Subject: Zion Nuclear Station Units 1 & 2
NUREG 0737 Item II.D.1
Performance Testing of Relief and Safety Valves
NRC TAC Nos. M44630 and M44631
Docket Nos 50-295 and 50-304

The reference letter transmitted to Commonwealth Edison Company (CECo) a Technical Evaluation Report (TER) which provided the results of EG&G, Idaho's review of CECo's response to the subject issue. The TER identified several apparent deficiencies in the CECo response.

CECo has reviewed the referenced TER and is providing as an enclosure to this letter our response to the identified deficiencies.

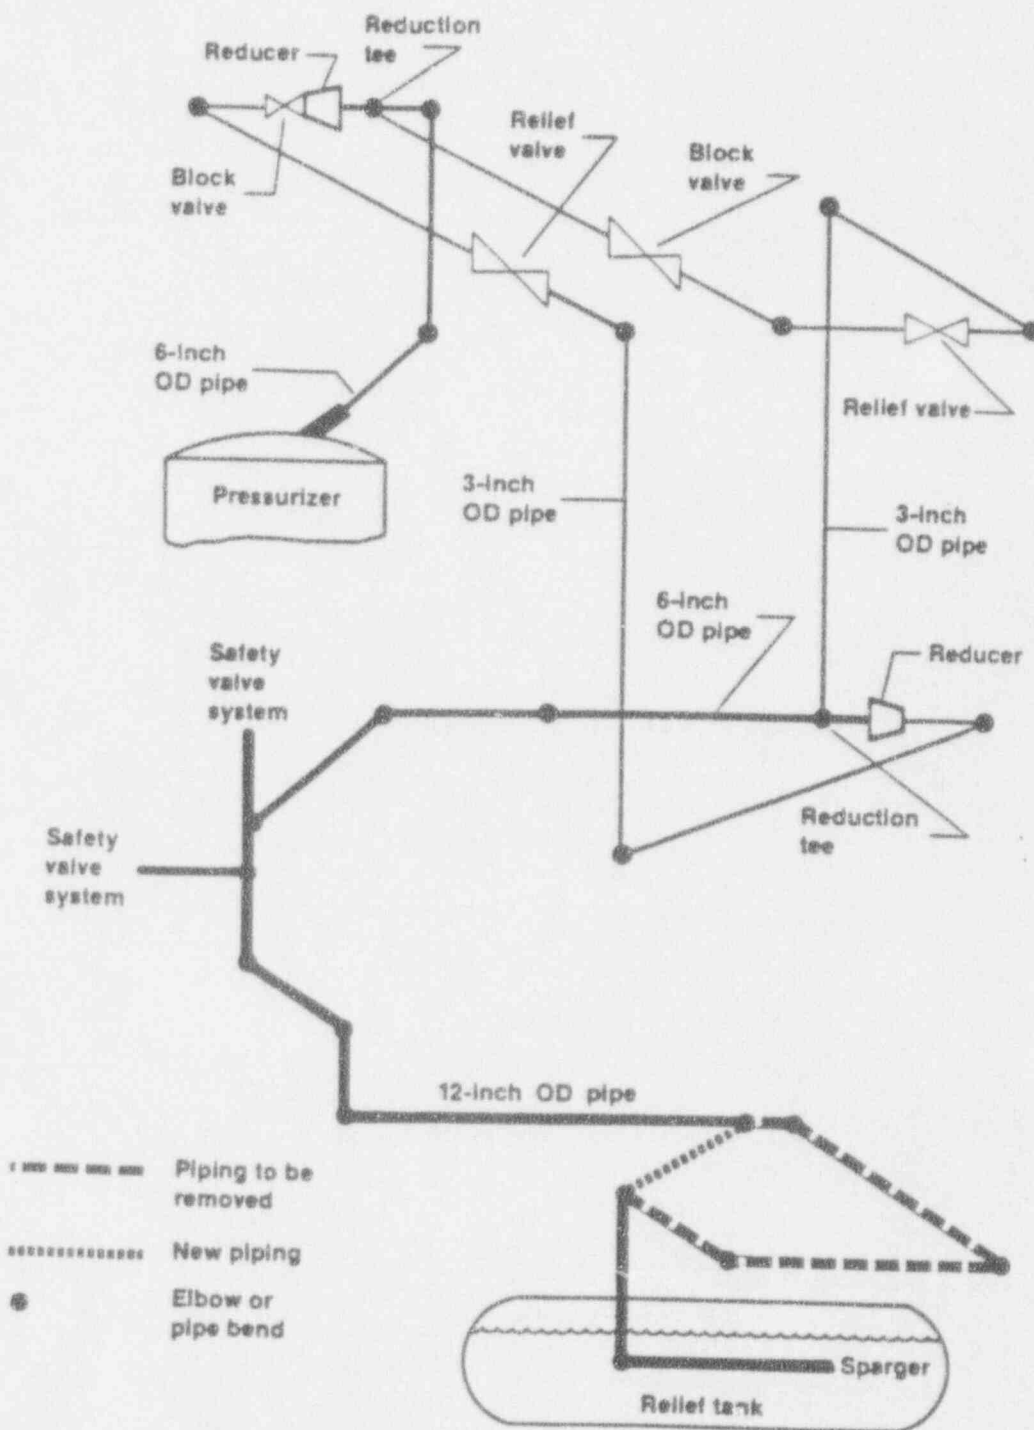
Item 3: Item 3, which requires the forces on the safety and relief valves to be maximized, was not met. This is because the Licensee did not provide the results of an analysis of the system for the PORV discharge or combine valve discharge loads with seismic loads. Therefore, it could not be concluded the forces were maximized.

This issue has been previously addressed in reference F. The portions of reference F which pertain to the analysis of the system for PORV loads are presented below:

The Zion pressurizer is equipped with two power-operated relief valves that are designed to limit system pressure. The relief valves can be operated automatically or by remote manual control and have a setpoint pressure of 2,349.7 psia. The operation of these valves serves to limit the use of the safety valves. The layout of the relief valve piping is shown schematically in the attached diagram labeled Exhibit 3.

The attached diagram labeled Exhibit 21 is a plot of the mass flow rate through the relief valves. The steady-state flow rate through the relief valves (junctions 1100 and 2300) is shown to be 288,000 lbm/hr. This corresponds to 137% of the manufacturer's rated flow. The RELAP5/MOD1 valve flow rate is also greater than the average flow rate of 241,200 lbm/hr measured during the EPRI/Wyle and EPRI/Marshall tests on Copes-Vulcan 316W/Stellite plug and 17-4 PH cage valves. The higher flow rate used in the analysis will predict higher loads and is therefore conservative for analytical considerations that address valve functionality and the structural integrity of the piping system.

The relief valve analysis revealed substantially lower loads in the common header piping than the loads calculated during the safety valve analysis. The lower loads are a result of the lower setpoint and flow rate for the relief valves and, more importantly, the absence of a loop seal in the relief valve piping. Therefore, the relief valve actuation was not pursued further for the response to NUREG 0737, item II.D.1, since the safety valve actuation is the bounding transient for the common header piping.
